Review of determination and stage 3 & 4 of the
East End Development at 121 Hunter Street
Newcastle

VISUAL IMPACT ASSESSMENT REVIEW

Prepared for: City of Newcastle

DOCUMENT CONTROL: Document no. 22224

P04 IMG 0025 : NEWCASTLE CLUB, WEST END MID-LEVEL (ADJACENT GROUND FLOOR) GARDEN TERRACE VIEW NORTH-NORTH-WEST
PHOTOMONTAGE - PROPOSED DEVELOPMENT

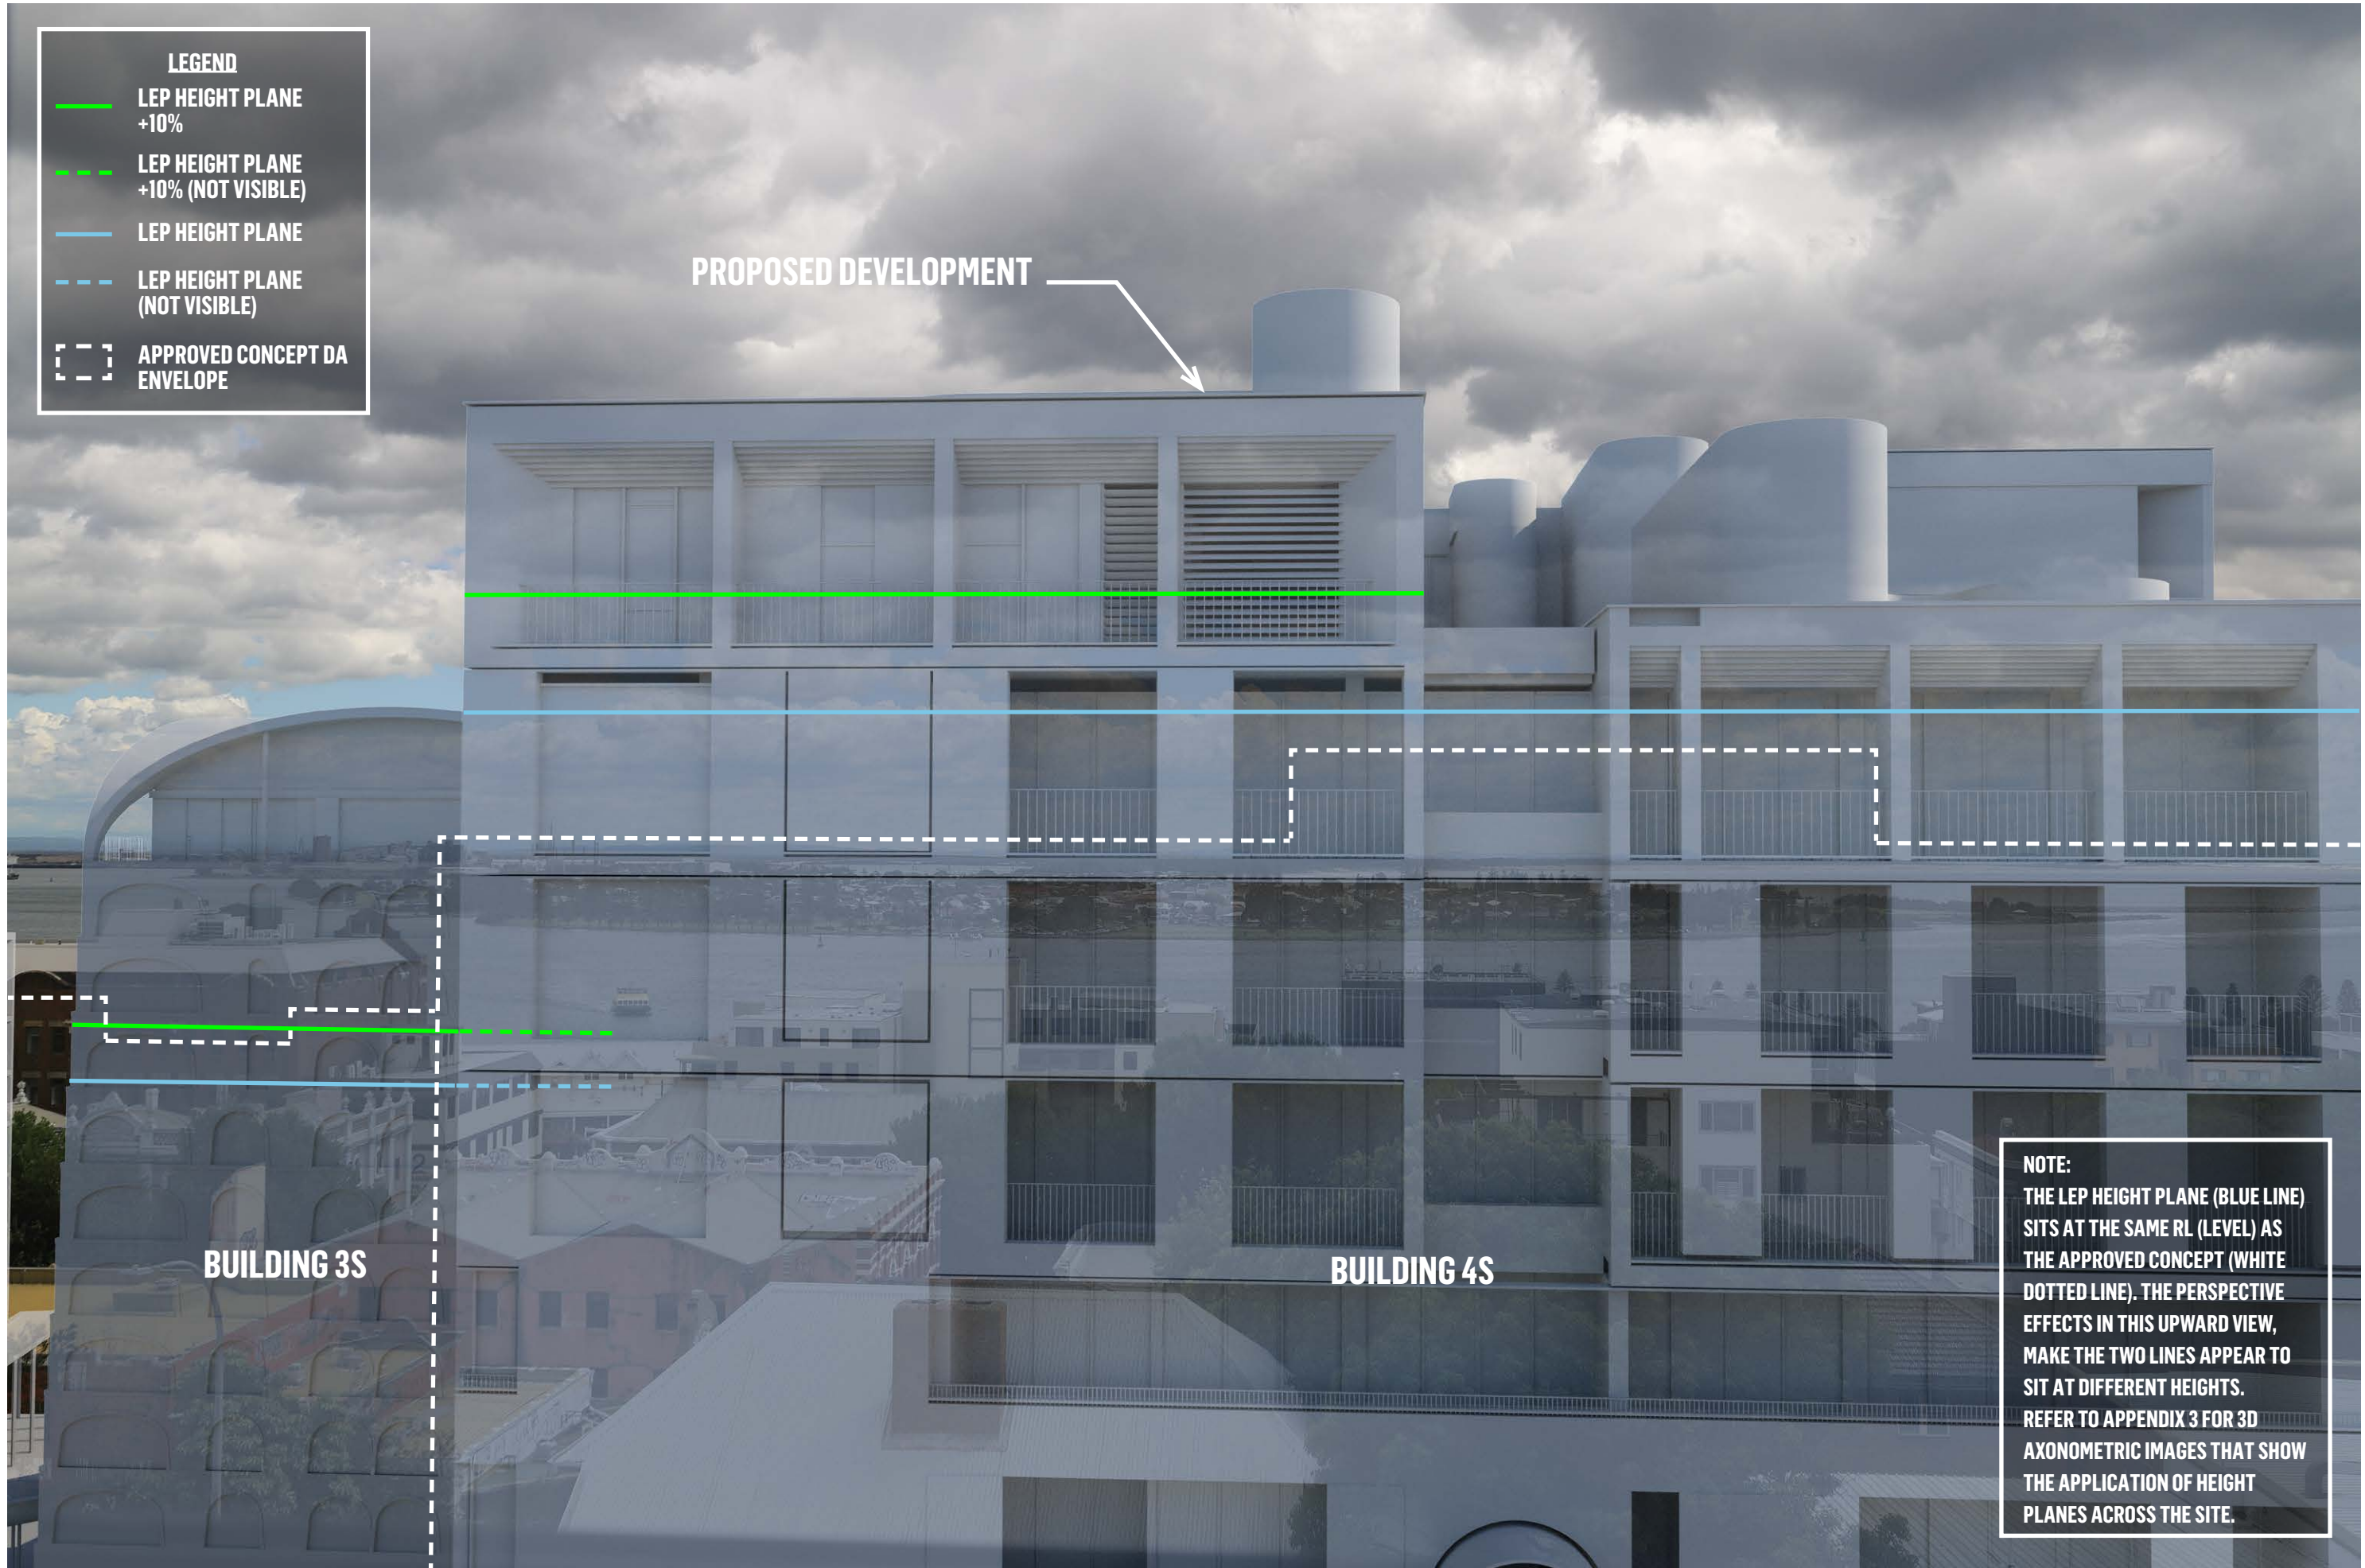
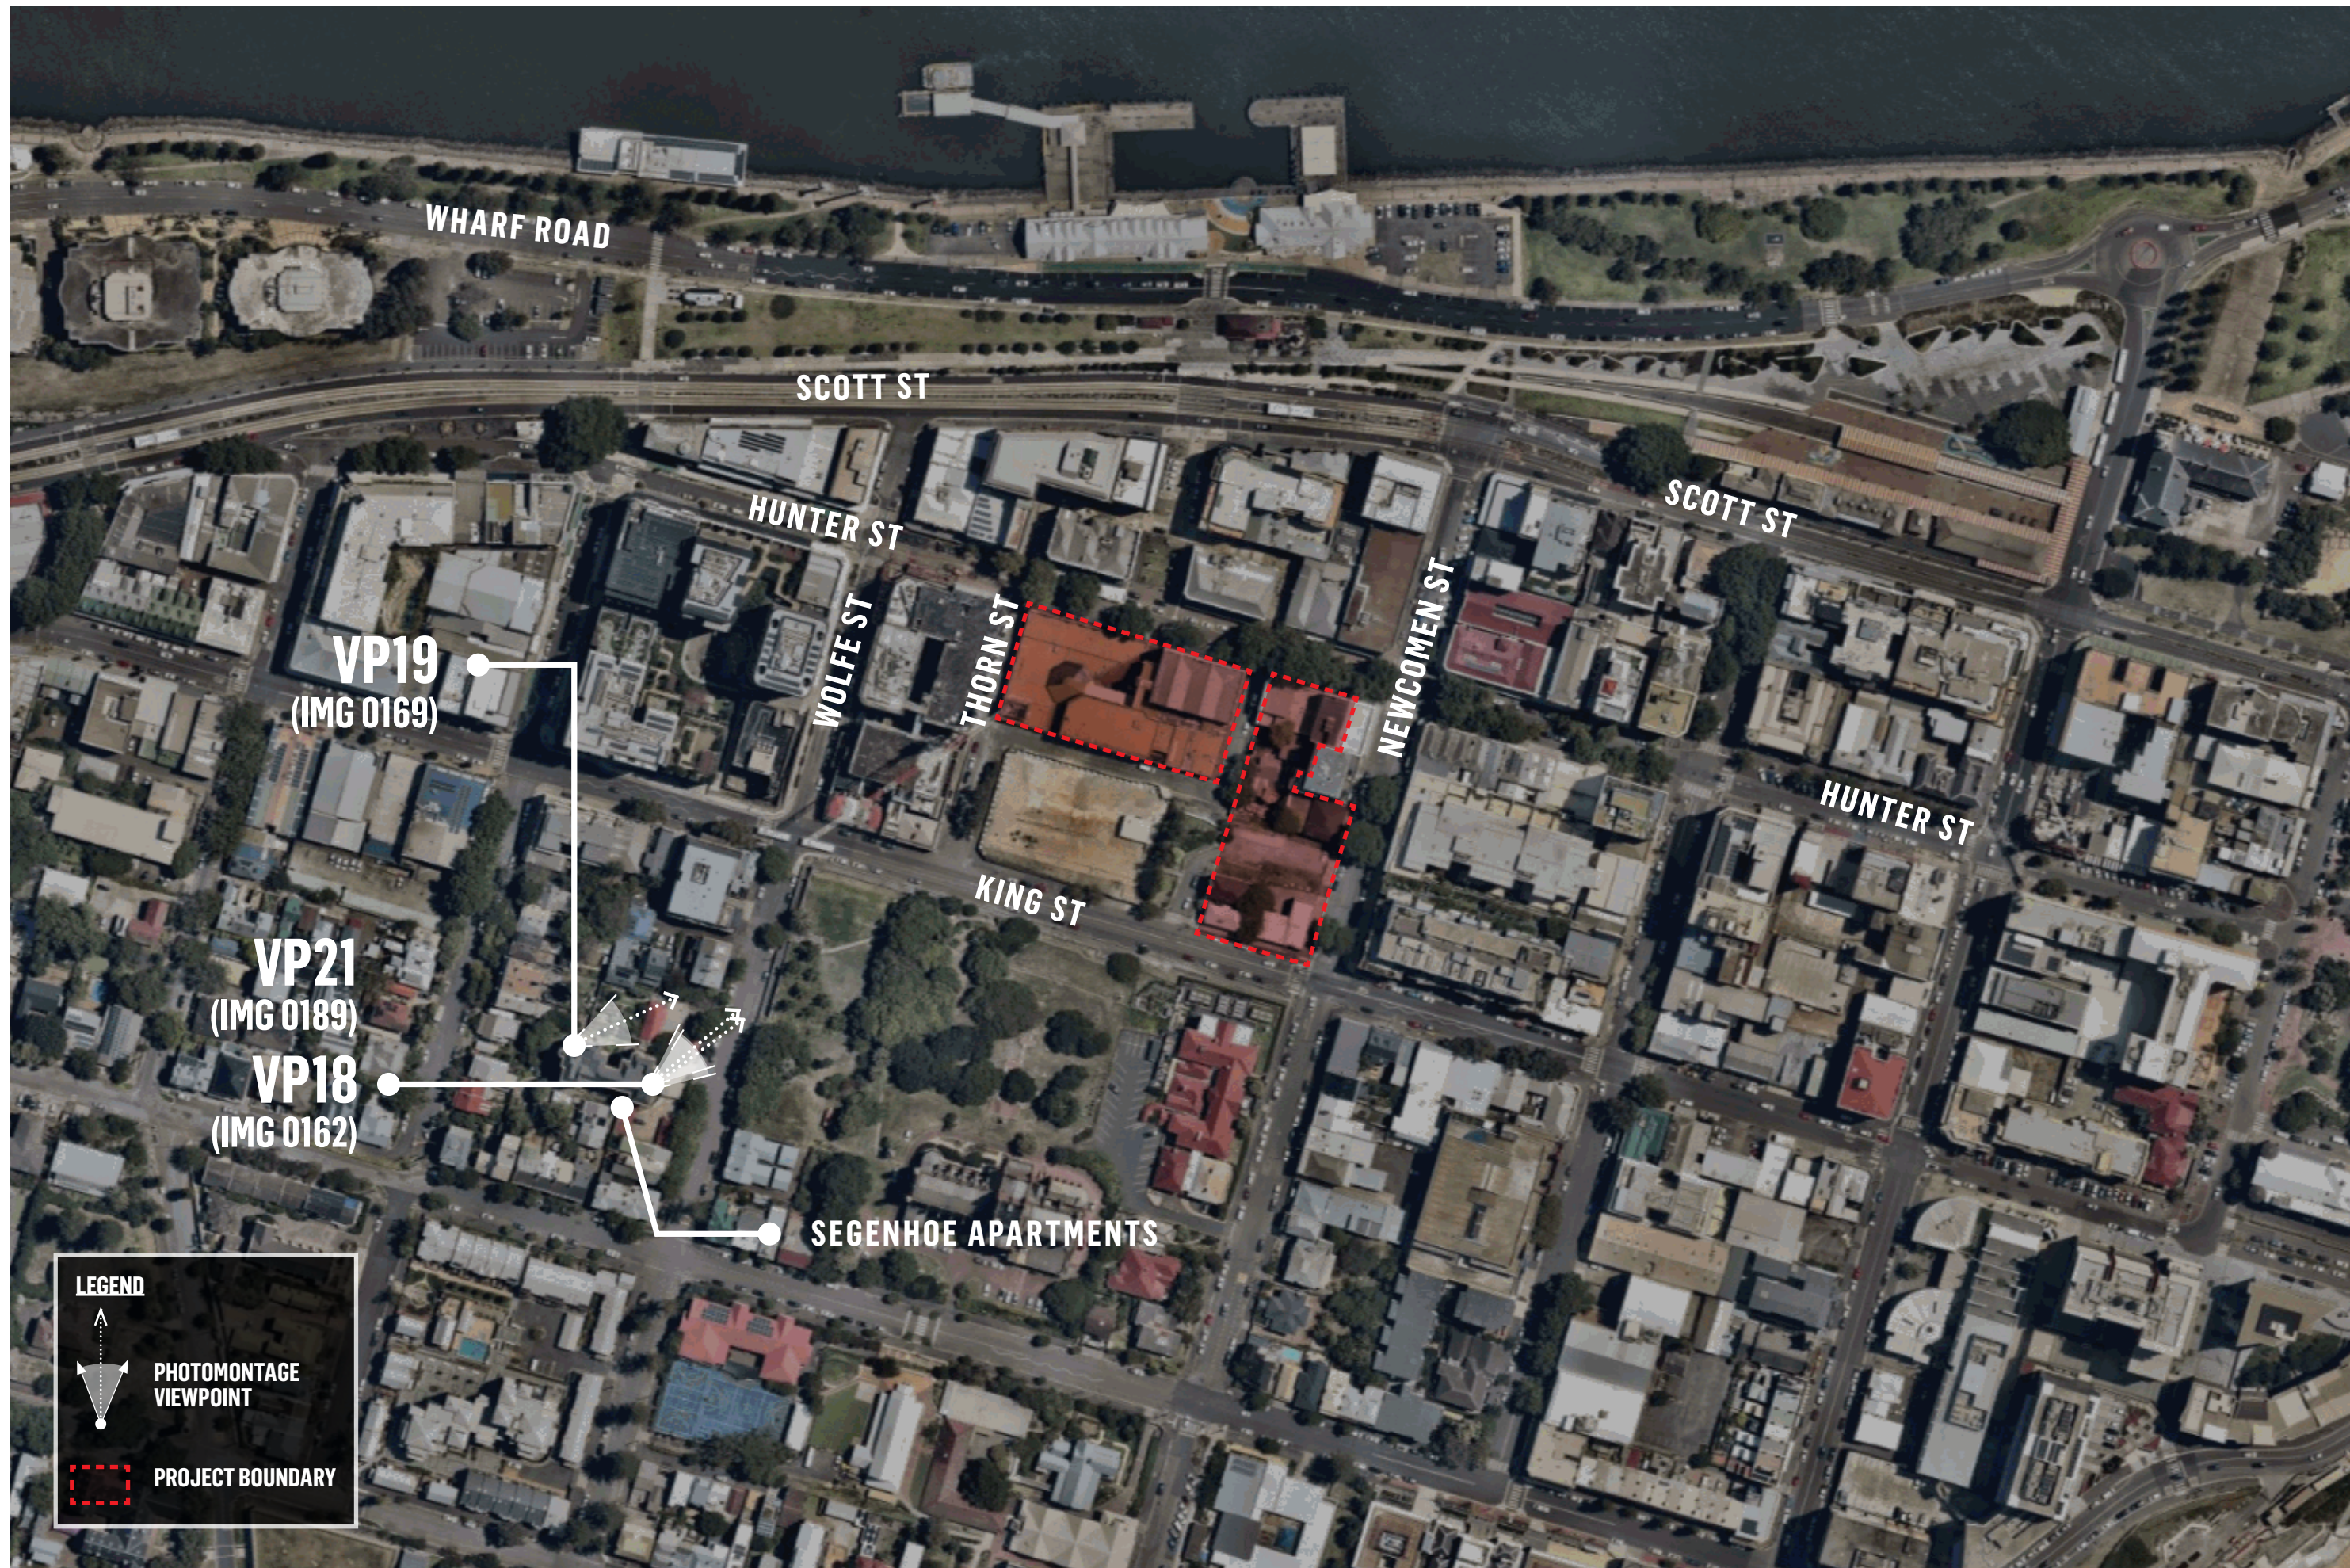
West end mid level garden terrace	Mid level	Yes	VP4 - does not show full view to E & 35mm focal length used	Moderate	Agree with impact rating, however, some assumptions made as entire	Neutral Little difference	Noticeably negative Loss of some harbour views/Stockton due to upper storeys (rating reflects value of	Neutral Little difference (additional sky lost)	Neutral No change
